1.5L OptiMax Compressor Temperature Sensor Torque Change Models Affected

Models Covered
Mercury/Mariner All 75–125 HP 1.5L OptiMax Engines

a - Temperature sensor

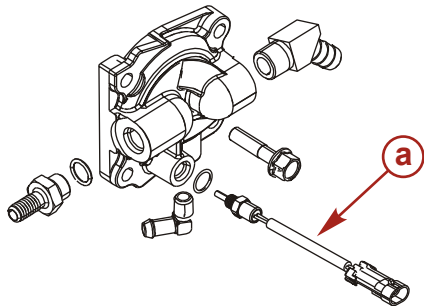
To prevent under cowl water leakage, the temperature sensor mounted on the air compressor cylinder head has a new torque. See the torque specifications following. Please use this new torque value when servicing the 1.5L OptiMax compressor. This information will be included in the next revision of the service manual.

This change was implemented with starting S/N 1B775632.

Description	Nm	lb-in.	lb-ft
Temperature sensor	13.6–20.3		10–15
